NOVI ACRES
JSP 25-0012

JSP25-0012 NOVI ACRES
Public hearing at the request of Cypress Partners, LLC for recommendation to the City Council for Amendment of the Consent Judgment that governs development of the property. The applicant is proposing a 61-unit multi-family residential development, a standalone retail building, and associated parking.

Motion Sheet

DRAWING TITLE
PRELIMINARY SITE PLAN- OVERALL

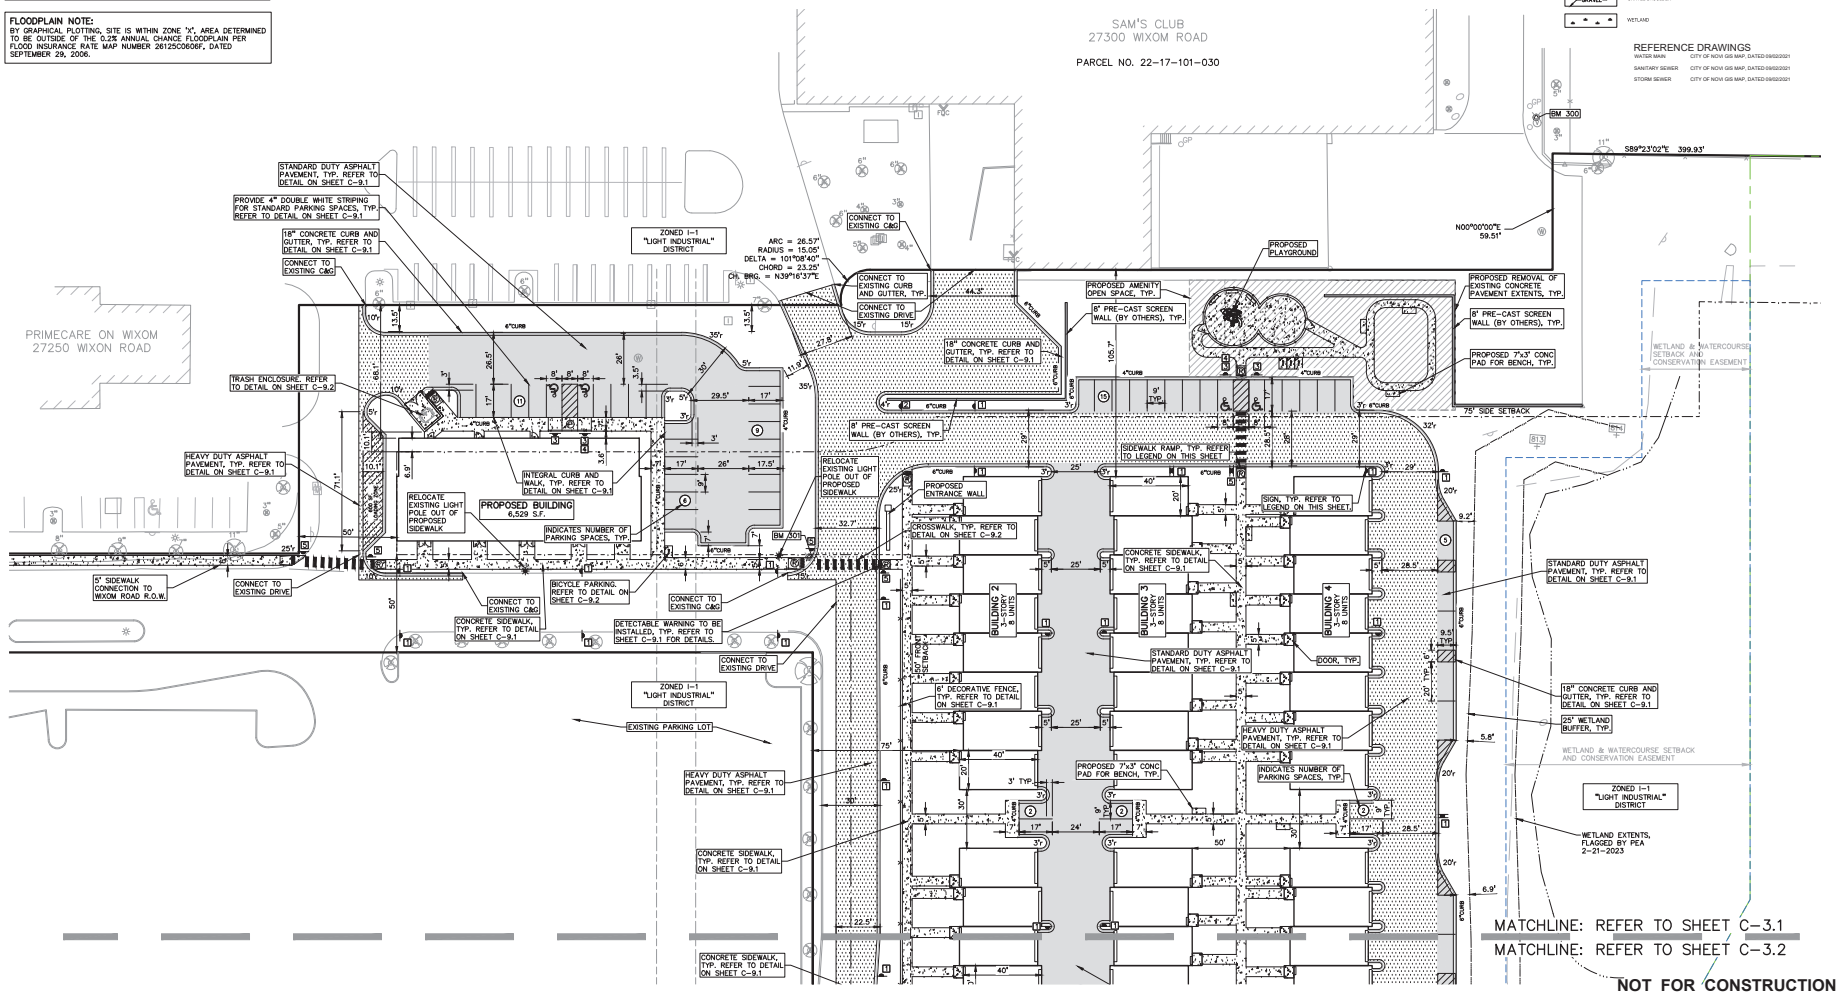
Item	Required Code	Proposed	Meets Code	Comments
Wetland/Watercourse Setback (Sec 3.6.2.M)	A setback of 25 feet from wetlands and from high watermark course shall be maintained	30.76 feet; see Sheet C3.0	Yes	
Retail, B-2 District: Note to District Standards *(Sec. 3.6)*				
Exterior Side Yard Abutting a Street (Sec 3.6.2.C)	All exterior side yards abutting a street shall be provided with a setback equal to front yard.		Yes	
Off-Street Parking in Front Yard (Sec 3.6.2.E)	Front yard parking permitted if setback requirements of district and landscaping standards of Section 5.5.3 are observed	No front yard parking proposed	NA	
Setback Abutting a Residential District (Sec 3.6.2.L)	Minimum yard setback shall be 20 feet	>20 feet	Yes	
Wetland/Watercourse Setback (Sec 3.6.2.M)	A setback of 25ft from wetlands and from high watermark course shall be maintained	30 ft.	Yes	
Parking setback screening (Sec 3.6.2.P)	Required parking setback area shall be landscaped per Section 5.5.3.			**See Landscape Review**

DRAWING TITLE
PRELIMINARY LANDSCAPE PLAN- OVERALL

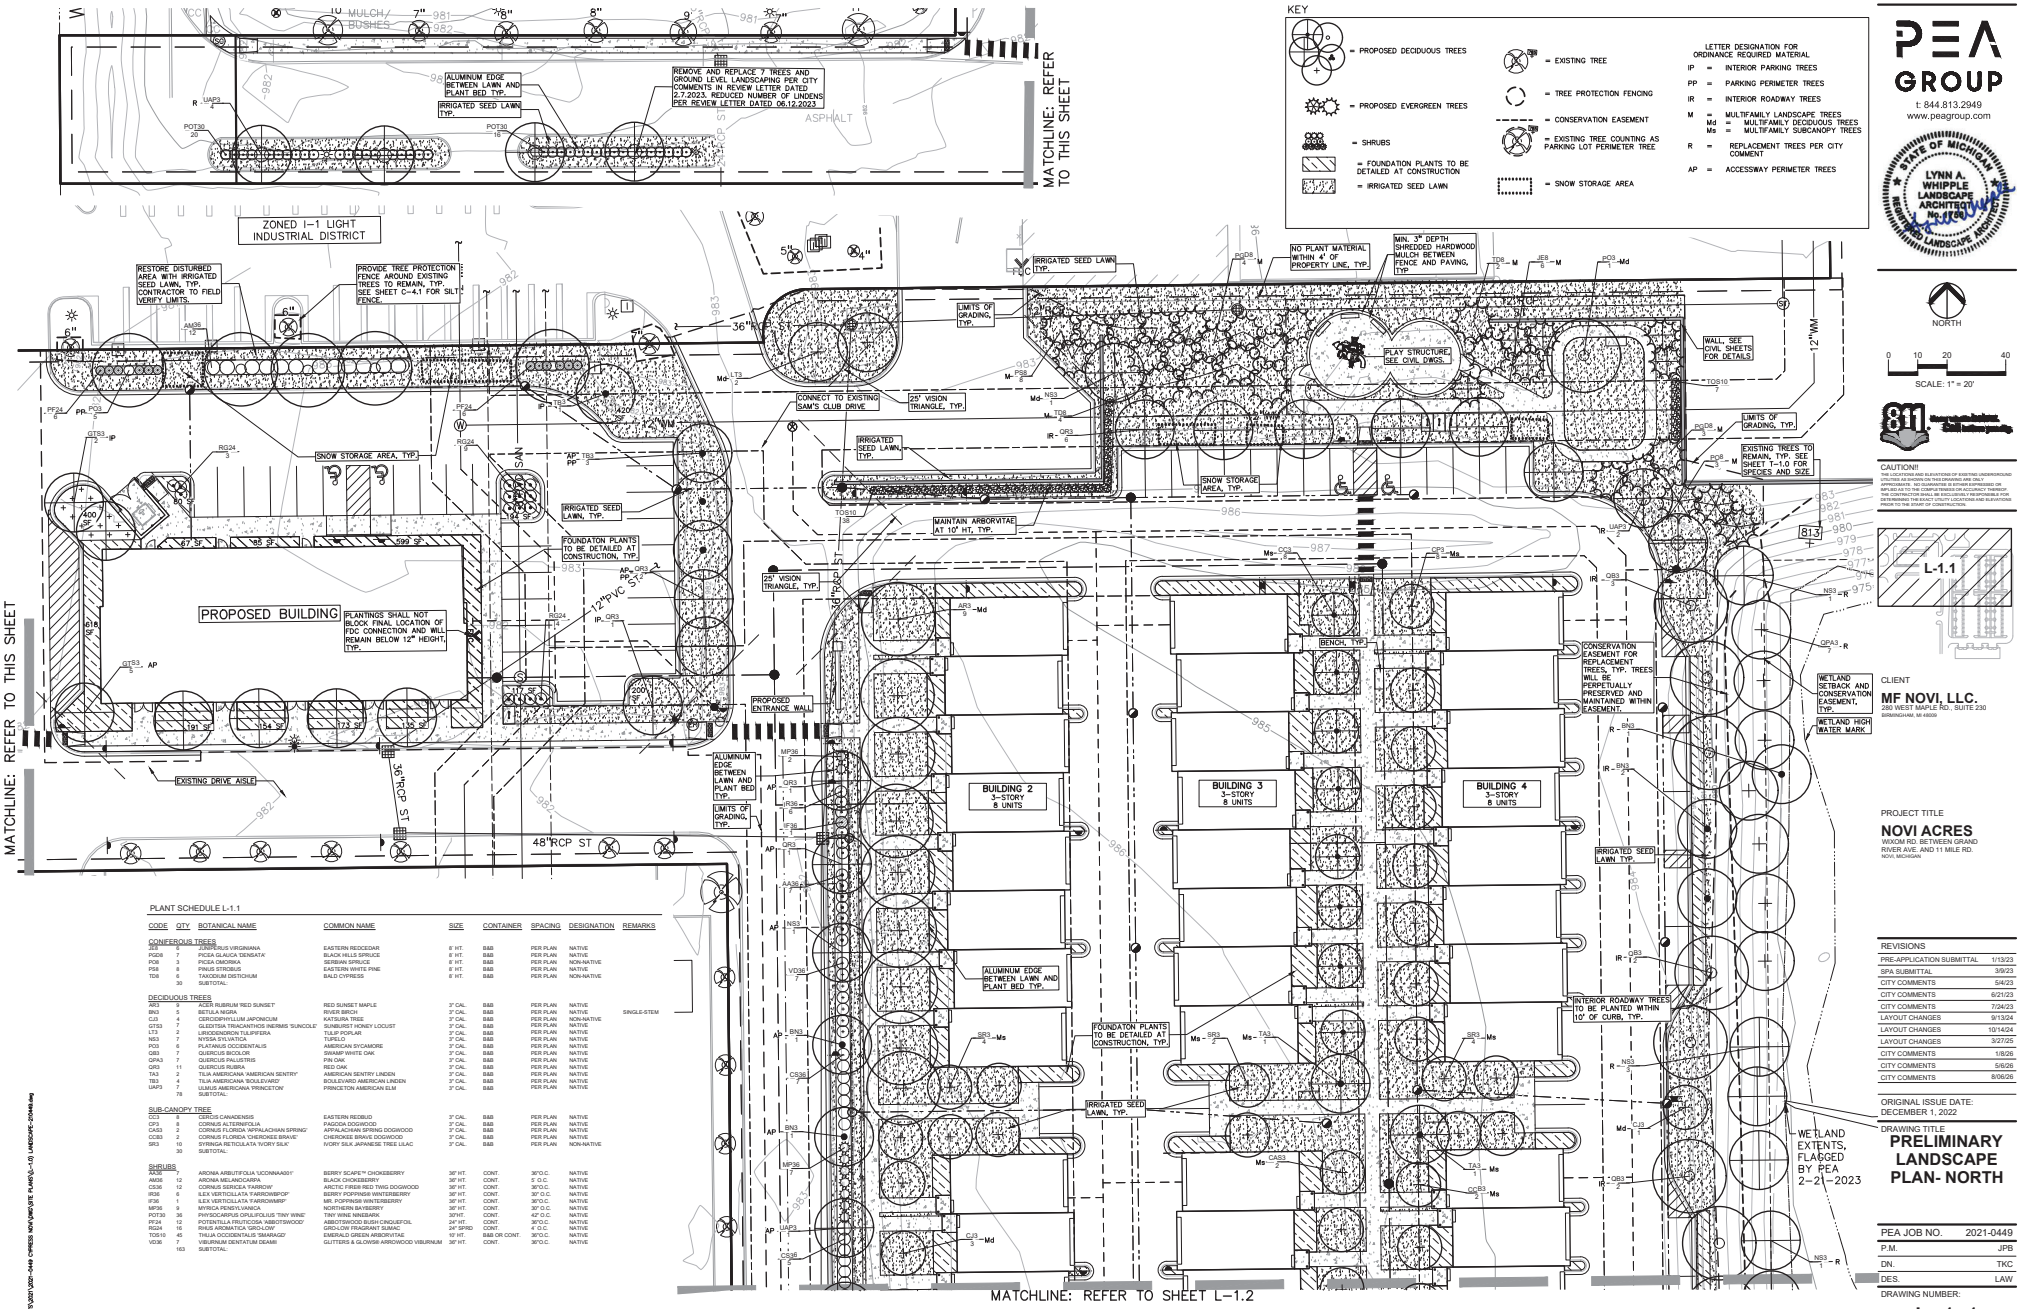
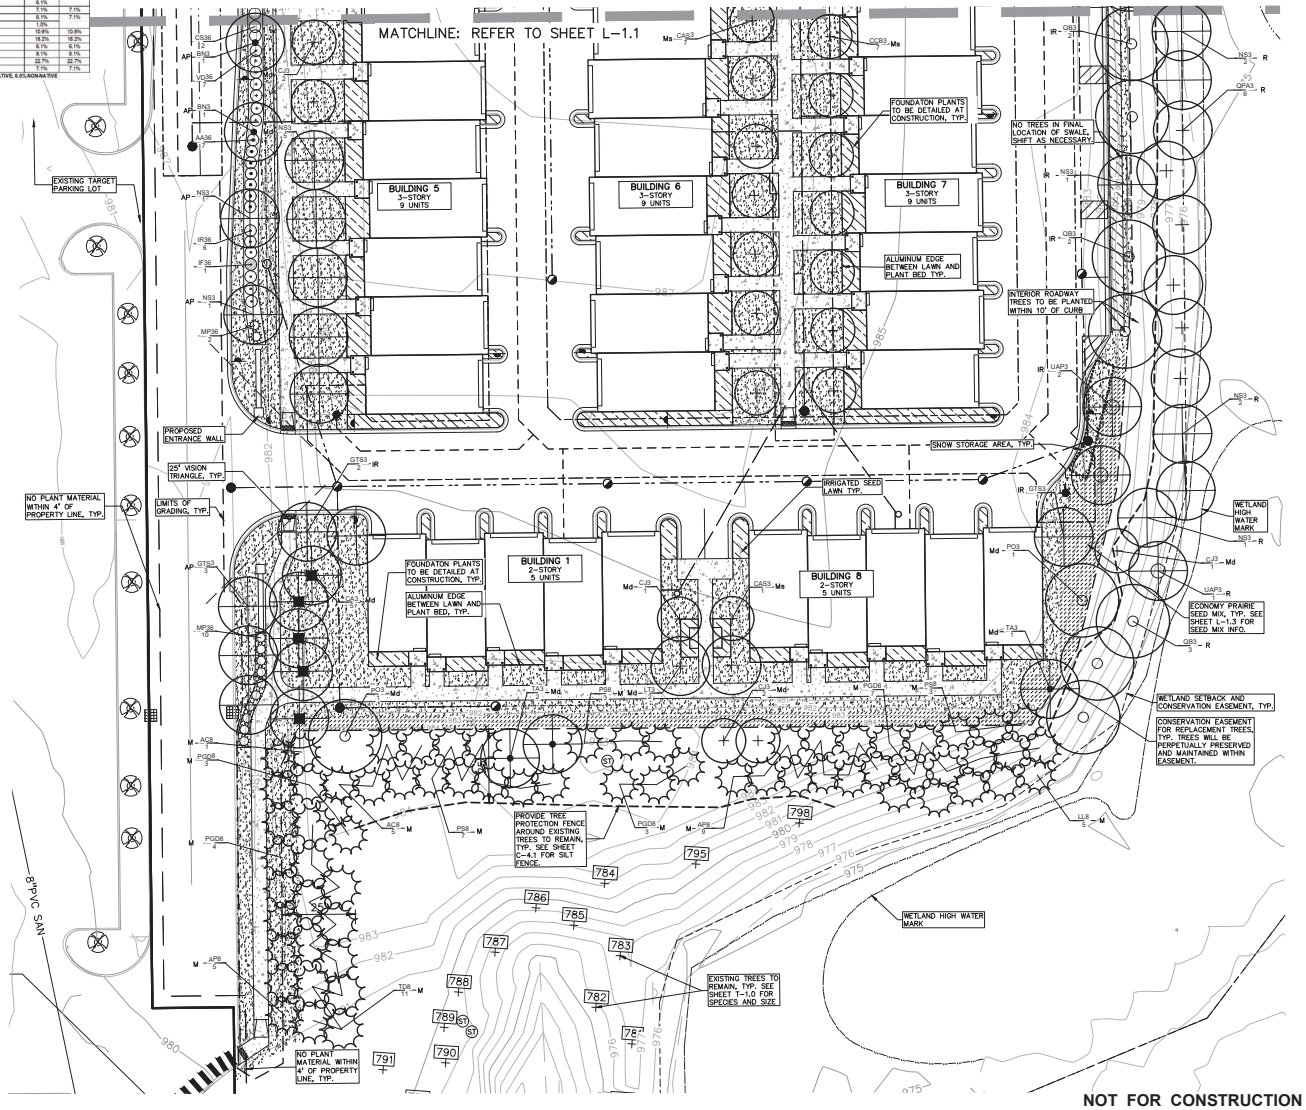
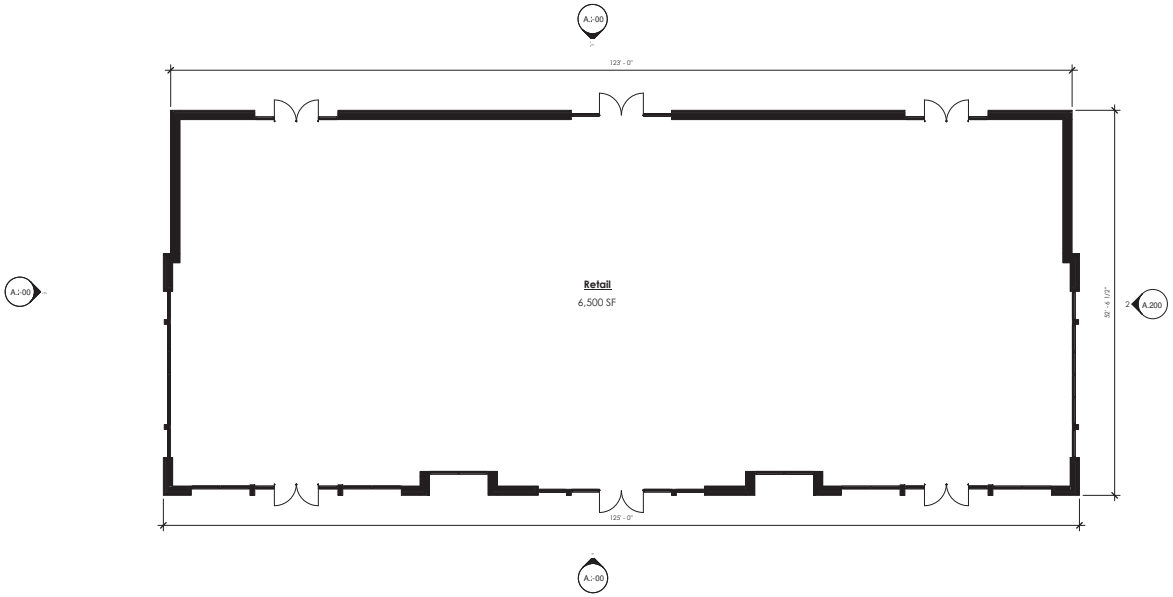
Engineering	Approval recommended	3/11/26	• Items to be addressed in the Final Site Plan submittal
Landscaping	**Approval not recommended**	9/3/26	**Deviations required:** • **Residential buffer** An 8-foot pre-cast wall with evergreens is proposed instead of a 6–8-foot berm (Supported due to site size) • **Deficient foundation landscaping for buildings 1,4,7, & 8** (Not supported)

Our project is more akin to the urban concept residential which is what the Main Street project is. With this additional foundation landscaping for these four buildings we are now able to achieve 12% for Buildings 1 and 8; 13.13% for Building 4 and 13.33% for Building 7. See Site Plan Sheets L 1.1 and L 1.2 and the Toll Color Renderings.
